Iowa Department of Transportation  
Office of Contracts

Date of Letting: April 19, 2011  
Date of Addendum: April 12, 2011

<b>B.O.</b>	<b>Proposal ID</b>	<b>Proposal Work Type</b>	<b>County</b>	<b>Project Number</b>	<b>Addendum</b>
114	77-8260-626	PCC Pavement - Grade & Replace	POLK	STP-U-8260(626)--70-77	19apr114.a03

# 10' RECREATION TRAIL PAVEMENT REINFORCEMENT DETAILS

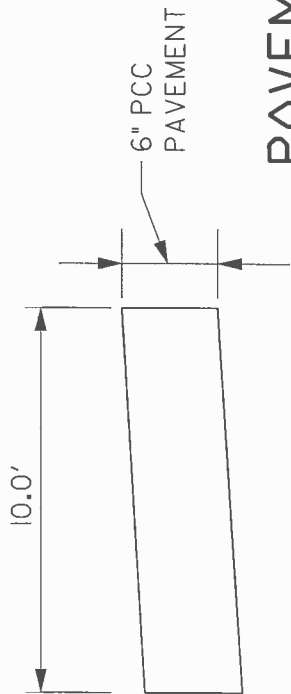
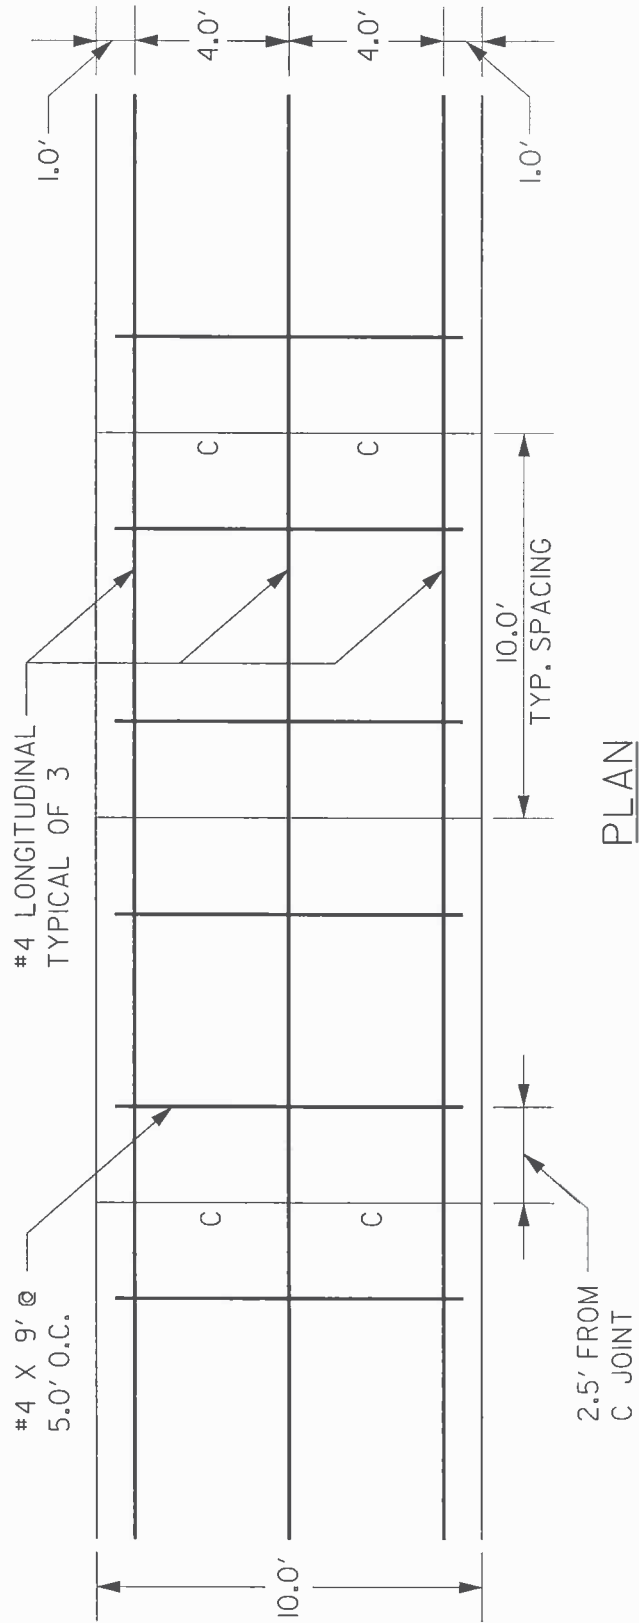
Make the following change to plan sheet B.03:

Add the attached Typical KM-5
